Traffic & Transport Assessment Addendum

Cabramatta East Planning Proposal

Project: Cabramatta East Traffic & Transport Assessment Addendum

Figure 1: Fairfield Street Peak Hour Traffic Volumes September 2019 and 2020

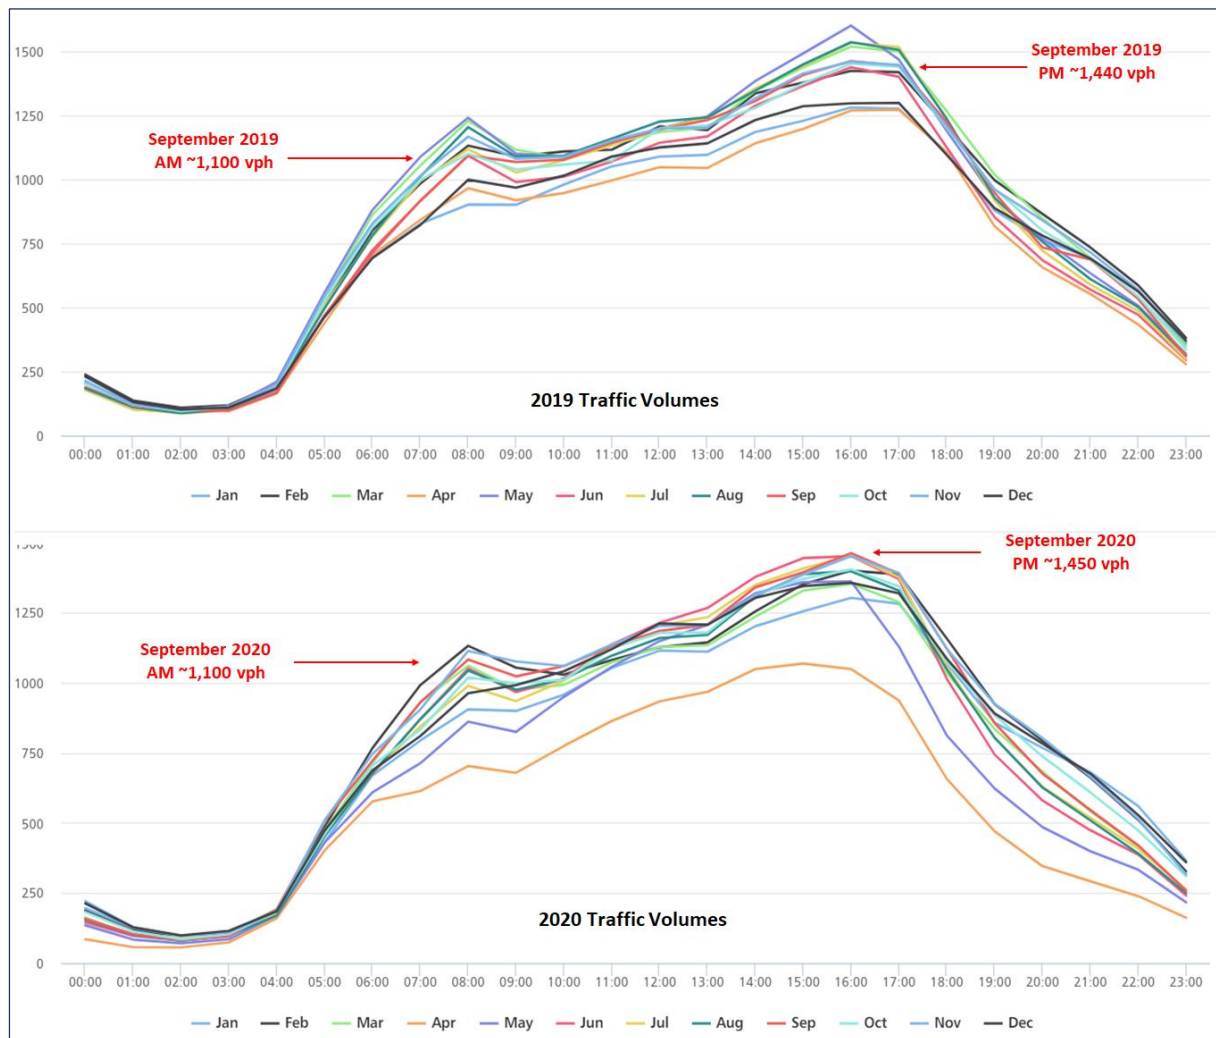
Notwithstanding the conclusions of the comparative assessment as requested by TfNSW, **arc traffic + transport** has sourced available data from TfNSW Count Stations in the Fairfield LGA to examine the difference between volumes in September 2020 (largely post-COVID) and September 2019 (pre-COVID) to ensure that the September 2020 surveys are appropriate for the comparison.

It is noted that it was the contention of TfNSW in our meeting on 7 May 2021 that traffic volumes had returned to pre-COVID levels by the time the September 2020 surveys were undertaken, but the analysis provided below provides an additional degree of certainty in respect to the analysis provided in [Section 3.2](#) above.

As shown in the figures above, traffic volumes in September 2020 had essentially returned to September 2019 pre-COVID levels in both roads, which validates the September 2020 surveys as suggested by TfNSW.
